# DELEGATED DECISIONS BY CABINET MEMBER FOR TRANSPORT MANAGEMENT

## DIDCOT: A4130 & B4016 LADY GROVE – PROPOSED TOUCAN CROSSINGS

Report by Director of Environment and Highways

TRAFFIC REGULATION ORDER  
TOUCAN CROSSING ON A4130  
FOR INFORMATION  
22-0179\_0100-100

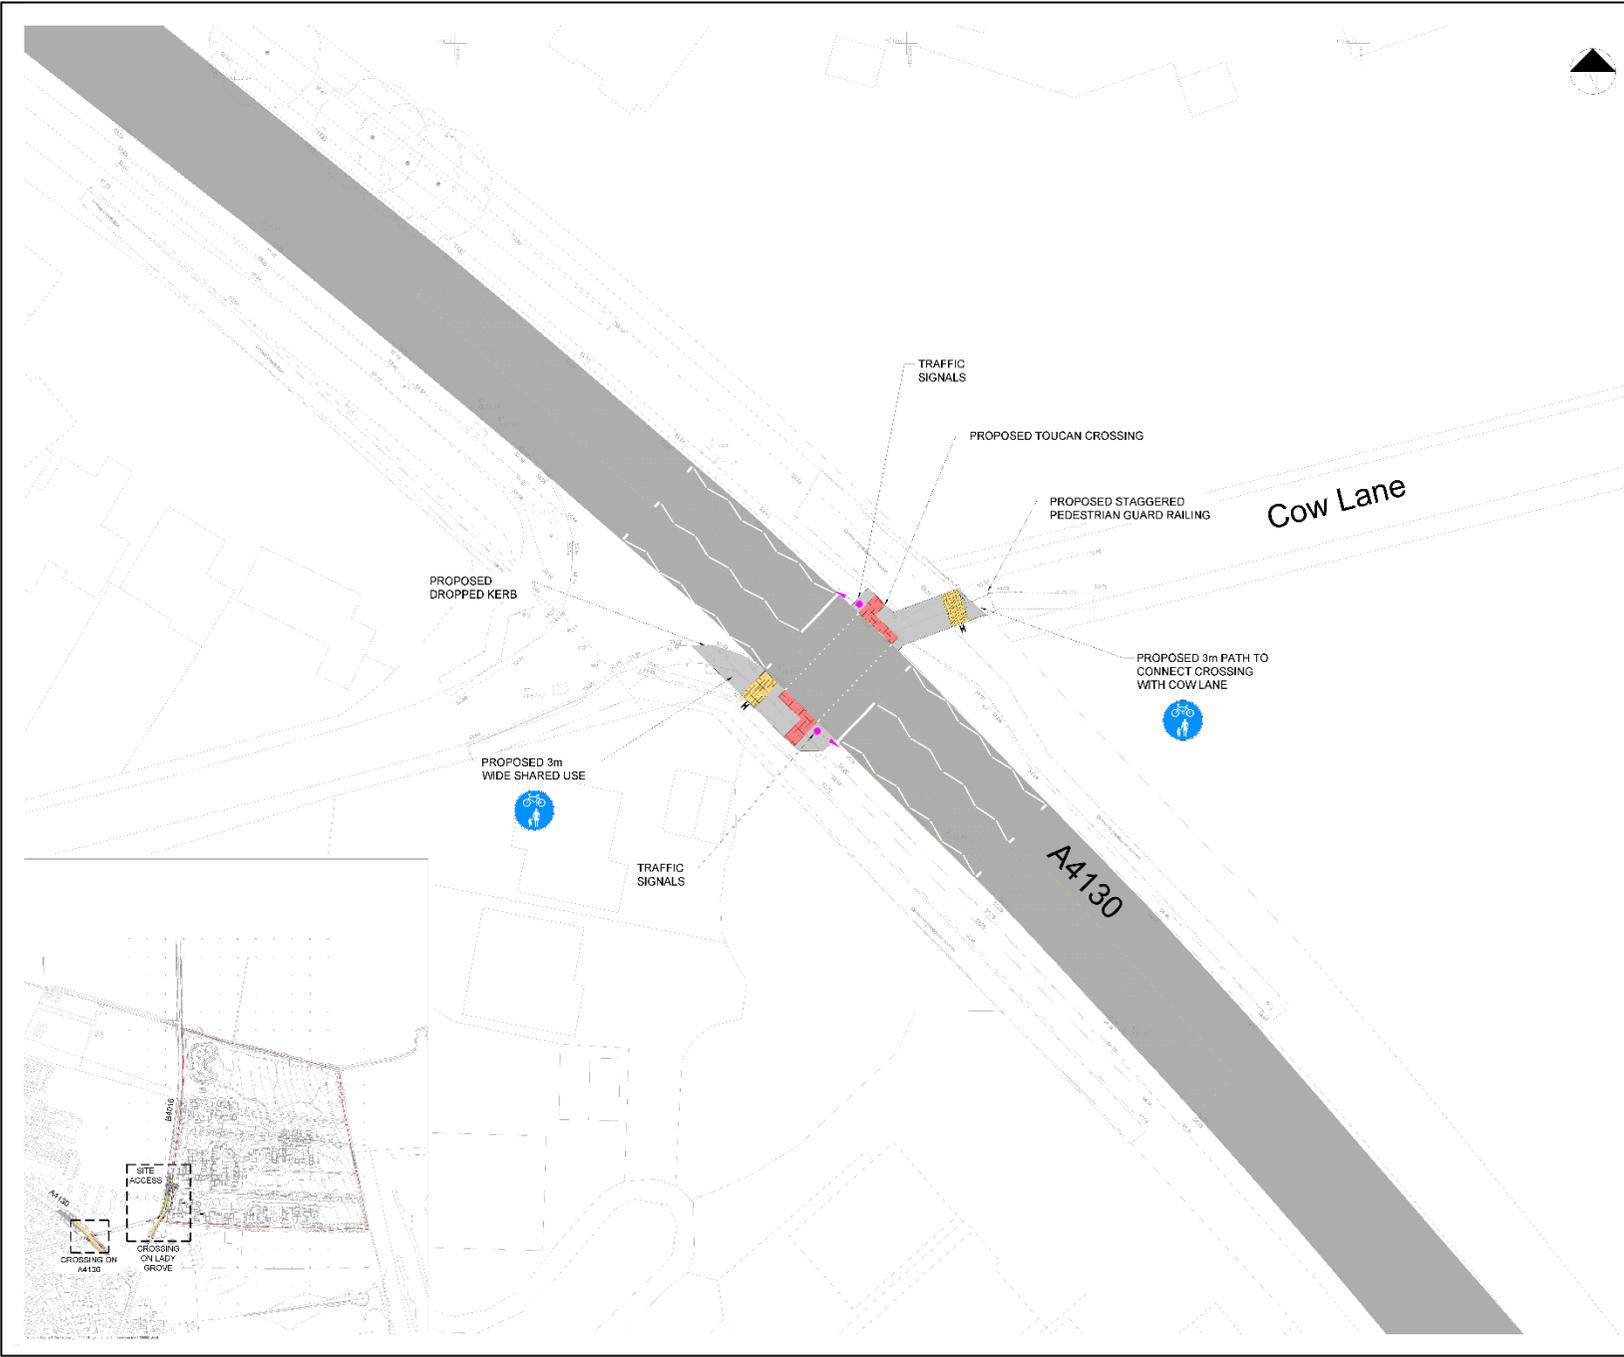
<p>(e5) Local resident, (Didcot, Ladygrove)</p>	<p><b>Partially support</b> – I'm pleased to see the correction to 'Toucan'.</p> <p>A staggered barrier is proposed at the bottom of a ramp from the A4130 to old Cow Lane as the route heads North. It's quite steep mud at present.</p> <p>Deletion of that proposed barrier and maybe regrading the ramp further to make a more gentle gradient would be a much better option. There is space to do so there.</p> <p>A barrier at that position, whilst marginally inhibiting downhill speed, would clearly make uphill cycling towards the crossing vastly more difficult as enforcing a near stop at the bottom of an incline when heading South. This would disproportionately effect and inconvenience users of non-standard bikes, such as those with trailer bikes or cargo bikes.</p> <p>Deletion of the barrier is definitely preferable and arguably required by current guidance LTN1-20 1.6.16</p>

<p>Please replace the staggered barrier with a central bollard to prevent vehicular access without obstructing cyclists.</p> <p>The removal of the rather randomly positioned existing 'cyclist dismount' sign on the end of the stopped up Old Cow Lane as it joins the South side of the A4130 at by the new Toucan would also be worthwhile.</p>
(e6) Local resident, (Didcot, Tortoise Shell)	<p><b>Support</b> – These toucan crossings would improve safety and the wellbeing of Didcot residents.</p>
(e7) Local resident,	<p><b>Support</b> – I don't think it changes my feedback.</p> <p>If I may -- is there any talk of revising the junction further up the road along Lady Grove -- where Lady Grove meets Willington Down?</p> <p>The junction is simply horrible. In 2024 (I'm told it was on boxing day) there was an accident that meant a lorry drove into the home of 6 Bradley Row (if you look on Google Street View, you can see how it was boarded up). It must have been horrific for the occupants and it's only in the last two months or so that the house has looked normal. (They've also now got extra protective posts at the side of the house.) I just hate pulling out of that junction and wondered if there were any plans to alter it.</p> <p>The other junction that would be lovely to convert to a roundabout would be the one between Lady Grove and Sires Hill.</p>

(e5) Local group/organisation, (Oxfordshire Liveable Streets)	<p><b>Object</b> – We object to this scheme, on the grounds that these crossings are on key cycling routes but fail to provide for cycling. They should be toucan crossings, or parallel crossings, or otherwise provide for cycling. The approaches to them also need to be designed for safe and comfortable cycling.</p>

That the plans propose "Cyclists Dismount" signs is in itself an acknowledgement that high demand for cycling across these crossings is expected. No other puffin crossings in the county come with such signs.

20. At the planning stage, the signalised crossing was identified as the most appropriate option due to the recorded vehicle speeds along the road, which were deemed unsafe for an uncontrolled crossing. This was especially true given the national speed limit change just to the north, making the signalised crossing the safest and most suitable choice. The exact location of the crossing has been chosen on a number of factors which includes consideration to road safety such as the speed limit, the visibility achieved, pedestrian and cyclist movements and proximity to existing junctions.
